ENGINEERING STUDY <input type="checkbox"/>		LAC - 92							
		CHANGE PROPOSAL <input checked="" type="checkbox"/>									
DATE 9/8/60		AFFECTS: WSPO <input checked="" type="checkbox"/>		PROJECT <input type="checkbox"/>							
NAME OF MAJOR COMPONENT SEAT PACK		PART OR LOWEST SUBASSEMBLY ---		PART NO. & MODEL OR TYPE Q-342							
TITLE OF PROPOSAL : IMPROVED SEAT PACK ASSEMBLY											
NATURE OF PROPOSAL : <div style="text-align: center;">SEE PAGE 2</div> <div style="position: absolute; top: 10%; right: 10%; border: 1px solid black; padding: 5px; transform: rotate(-15deg);"> <i>Our simple ECP's have now gotten up to 10 pages Is "Que Sera, Sera!"</i> </div>											
REASON FOR PROPOSAL : 1. To incorporate improved seat pack deployment and life raft inflation provisions 2. To incorporate fiberglass survival gear container. 3. To incorporate an improved ship to kit disconnect coupling with automatic green apple actuation. 4. To incorporate thigh strap, harness and kit to man quick disconnect.

LAC -92

IMPROVED SEAT PACK (Q-342)

FIG. 1

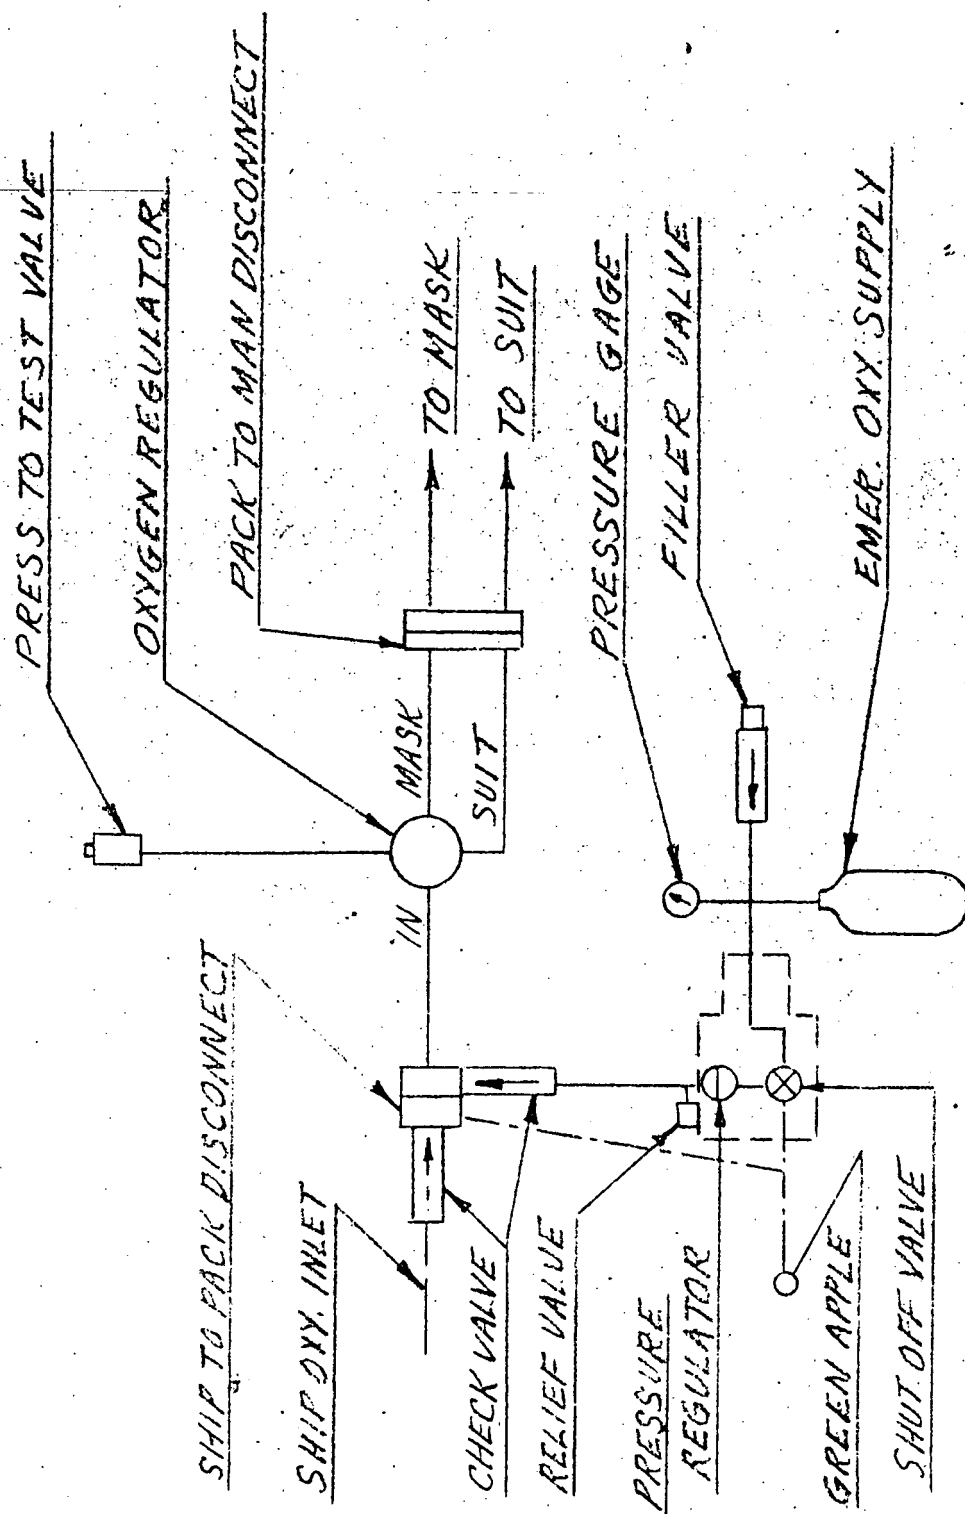
Oxygen System - (See Oxygen System Schematic - Figure I)

Reduced pressure oxygen is directed from the airplane system through the ship to pack disconnect. An emergency source of 96 cu. in. oxygen is supplied which is 1.7 times that in the system now in use in the existing Q-198 packs.

The Q-342 oxygen system incorporates two disconnects. The first disconnects the pack from the ship's oxygen supply and at the same time automatically activates the emergency oxygen supply in the pack. The second disconnect will free the mask and suit hoses from the pack as the first operation in the sequence initiated by operation of the release handle controlling deployment of the kit.
